PRELIMINARY ASSESSMENT REPORT: Addendum

For the Revised Location of Markham MTS No. 4

CAA ID No. 2002-054

Date: 15th July 2002

DIAGRAM 4

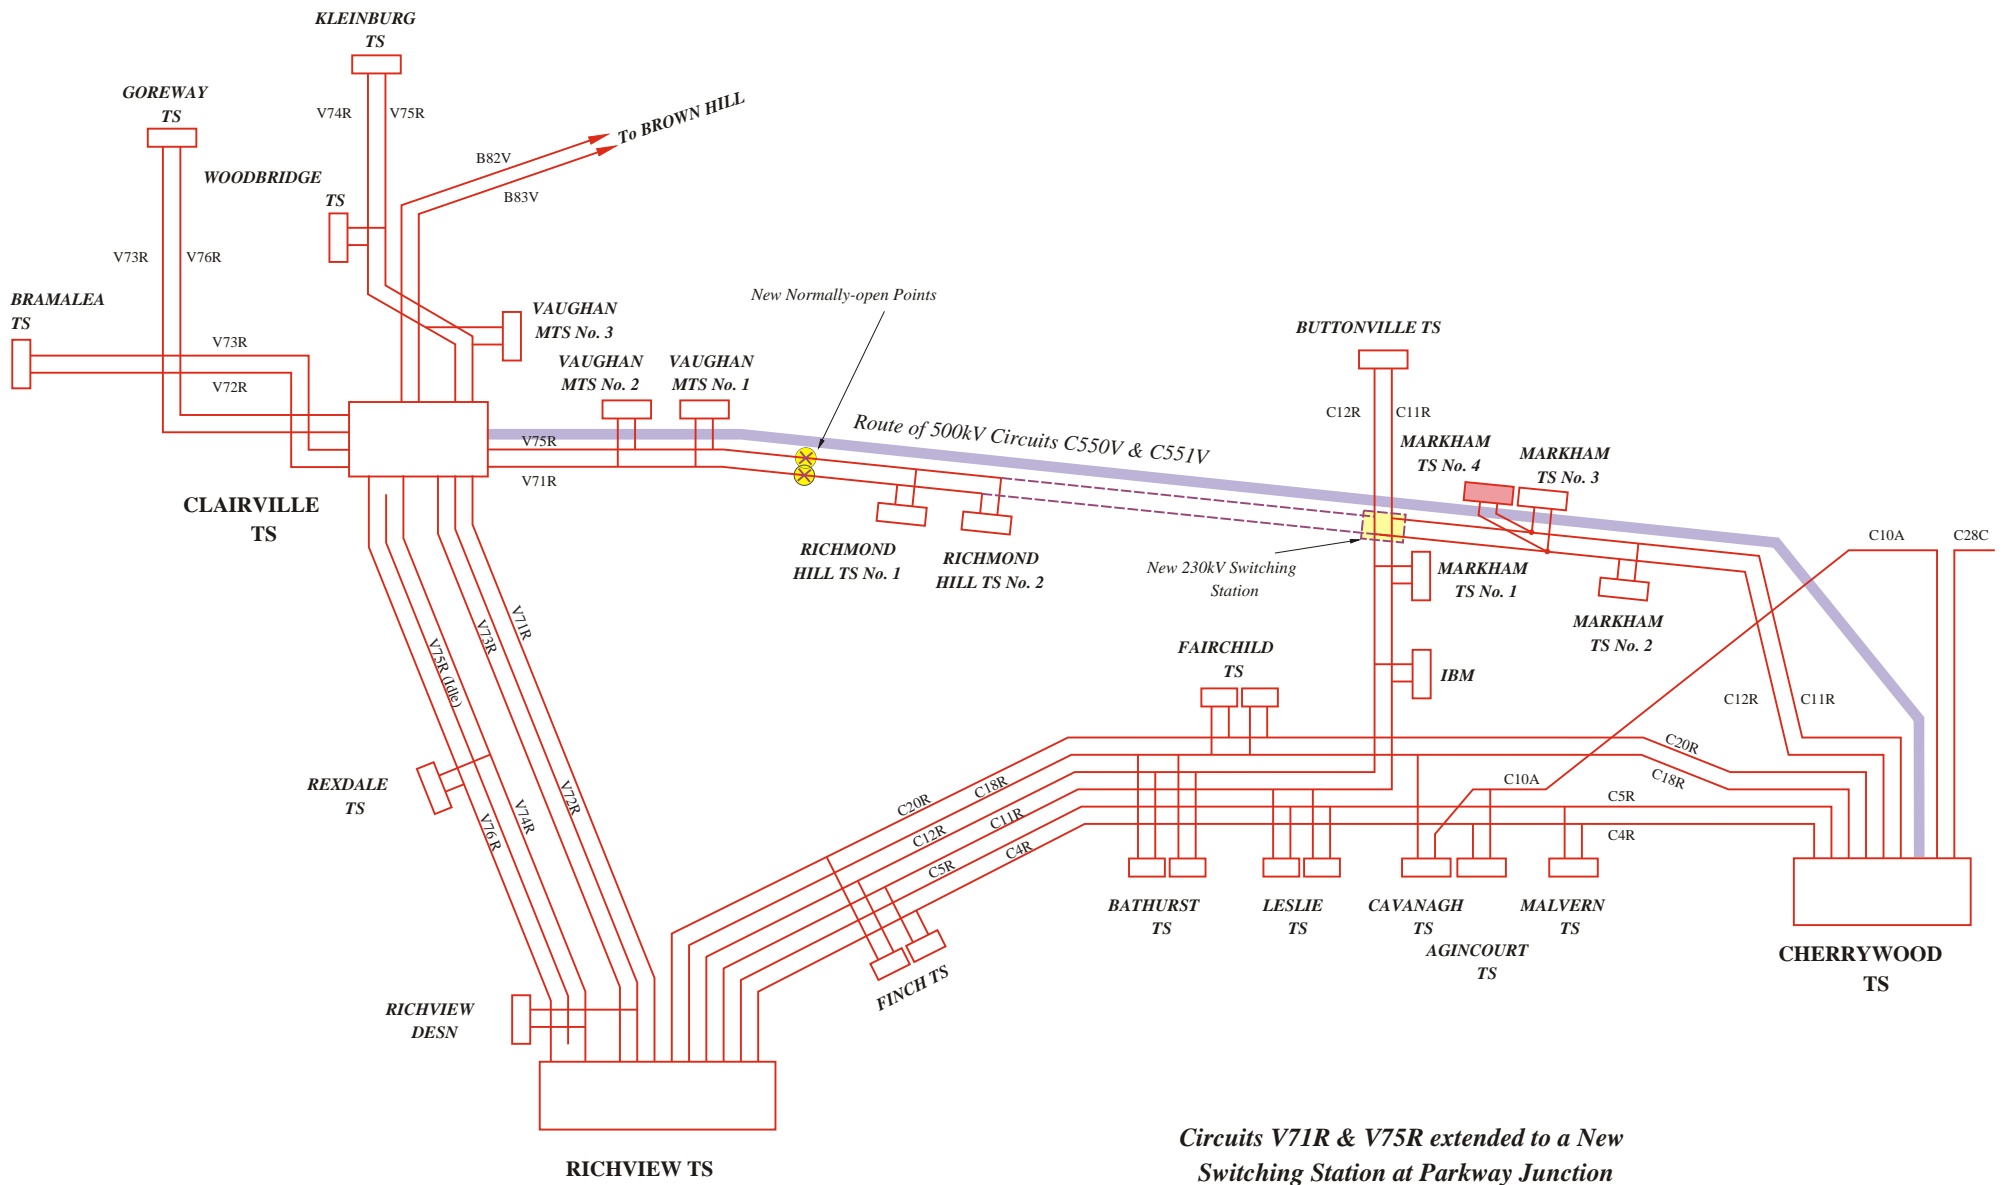
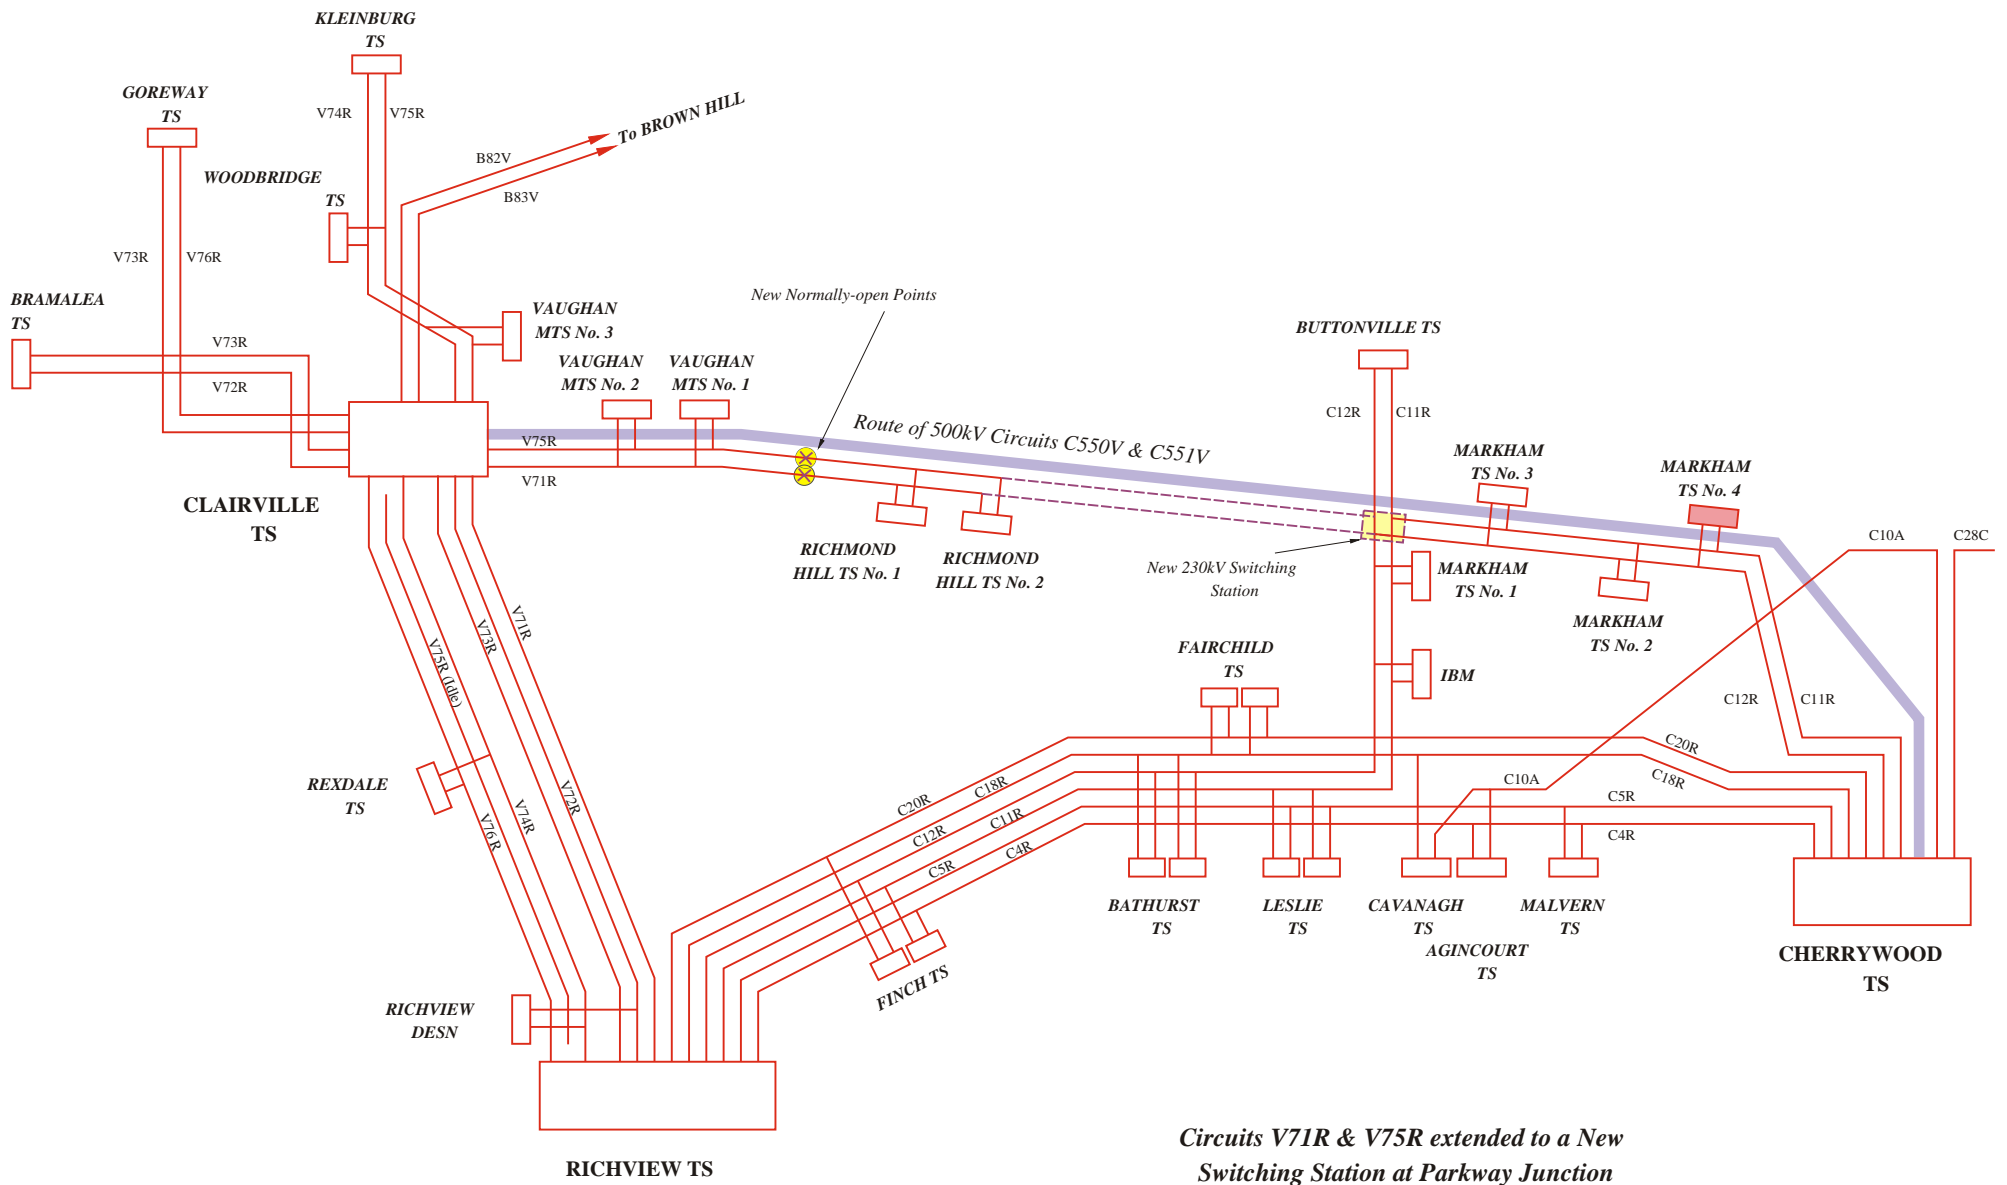
Diagram 4 shows the proposed arrangement with a new switching station established at Parkway Junction, together with new normally-open points located in circuits V71R & V75R.

While the introduction of normally-open points into circuits V71R & V75R would have a negligible effect on the normal flow distribution, with all elements in-service, it would result in an increase in the post contingency flows on circuits C11R & C12R for contingencies involving the companion circuit. This is due to the interruption of the path through circuits V71R & V75R, preventing a greater proportion of the load on these circuits being supplied post-contingency from Claireville TS via the two 500kV circuits.

Should a new switching station be developed at Parkway Junction, then the IMO's preferred connection point would therefore be on the section of circuits C11R & C12R between the new switching station and Cherrywood TS, as shown in Diagram 4.

Markham Hydro is encouraged to consult with Hydro One on the possible form that their proposal will take for addressing the IMO's concerns since this could influence the connection arrangement for the new MTS. However, should Hydro One's proposal involve the development of a new 230kV switching station at Parkway Junction, then the preferred location for the connection of the new MTS would be on the section of circuits C11R & C12R between Parkway Junction & Cherrywood TS as shown in Diagram 4.

Provision of Additional Transmission Support to a new Switching Facility at Parkway Junction (230kV Option)

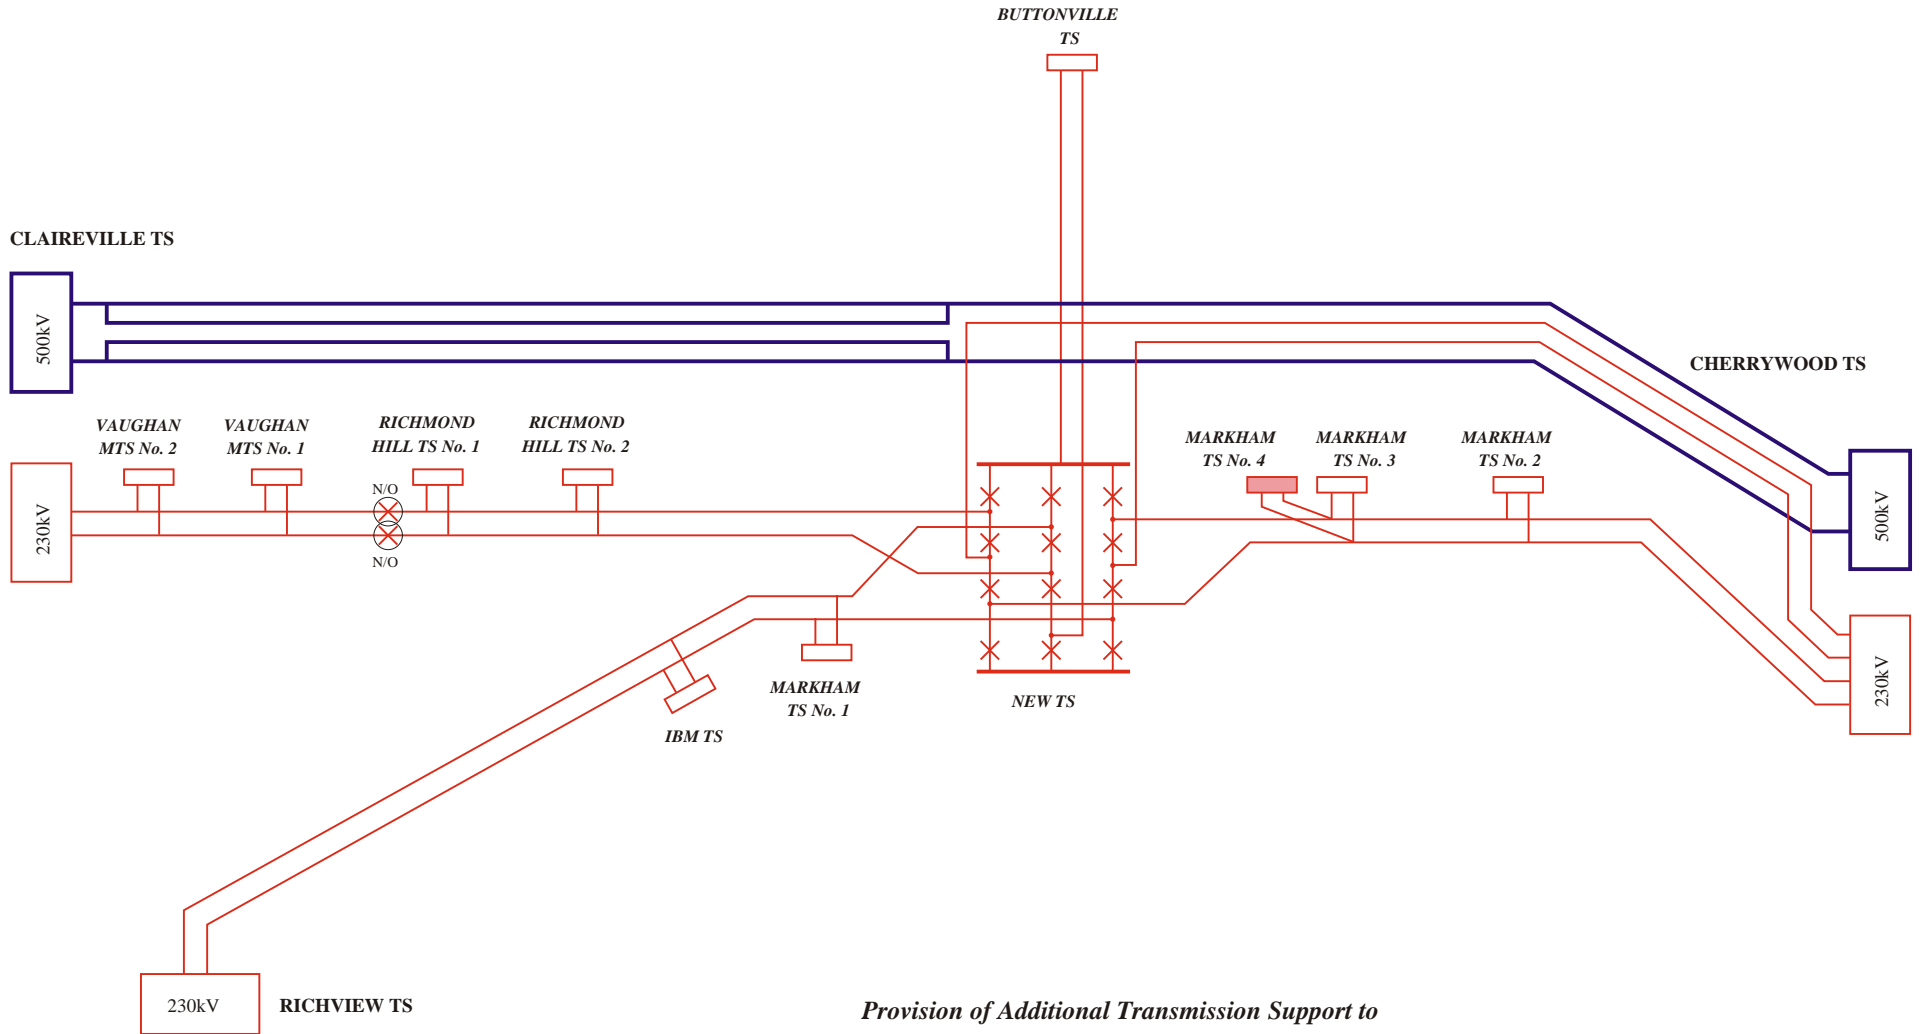
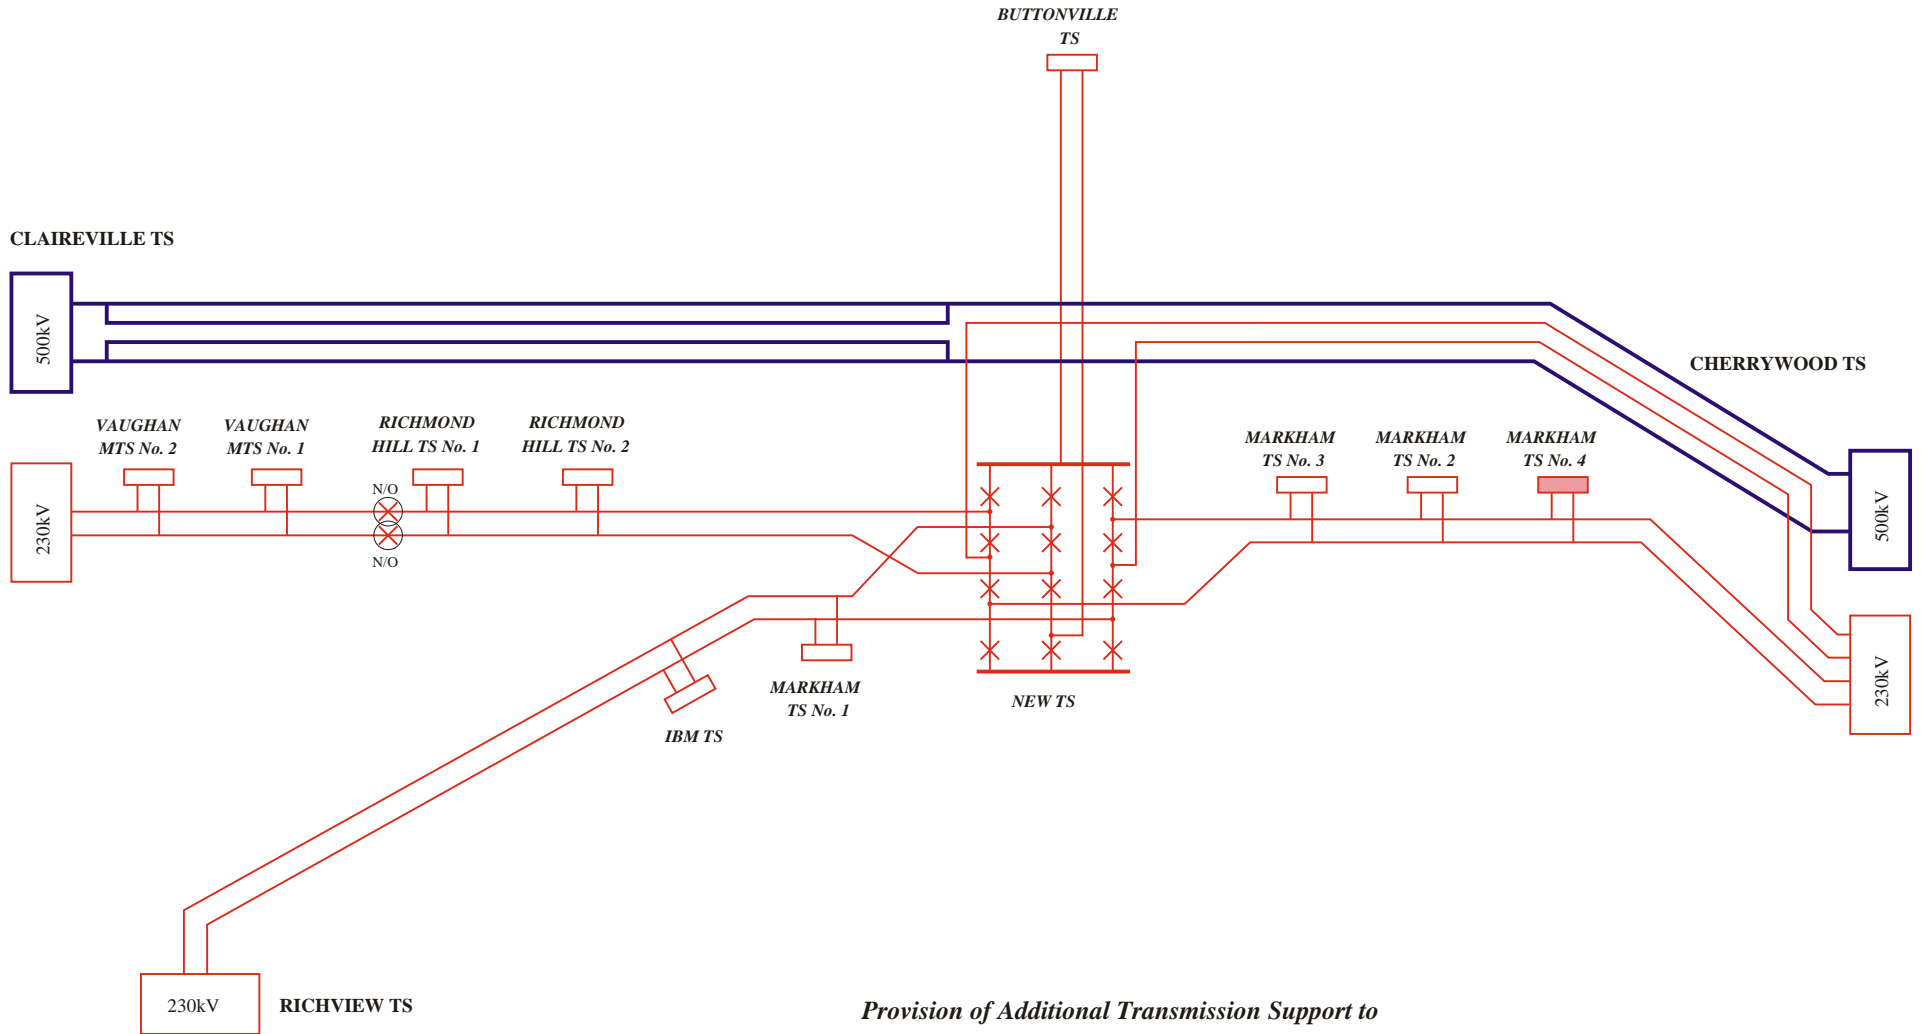
Diagram 5 shows an arrangement that uses two of the 'paired' 500kV circuits between Parkway Junction and Cherrywood TS to provide additional 230kV connections into Parkway Junction switching station. These two circuits would need to be reterminated on to the appropriate 230kV busbar at Cherrywood TS and on to the new busbar at Parkway Junction SS so that they can then be operated at 230kV.

These circuits would provide relief for circuits C11R & C12R and allow for possible future growth in the area. Furthermore, since the rating of each of the 500kV circuits between Claireville TS and Cherrywood TS is limited by their respective terminations, there would be no serious reduction in the thermal performance from operating one of the 'paired' circuits of each transmission line at 230kV.

- Although it would require additional 230kV breakers to be installed at Cherrywood TS together with some additional line work, it would avoid the cost of installing the two new 500/230kV auto-transformers.
- It would have less of an impact on fault levels than the arrangement shown in Diagram 6.
- The two auto-transformers could be installed at a later date when justified by increasing load in the area and/or the need to restore the two circuits to 500kV operation.
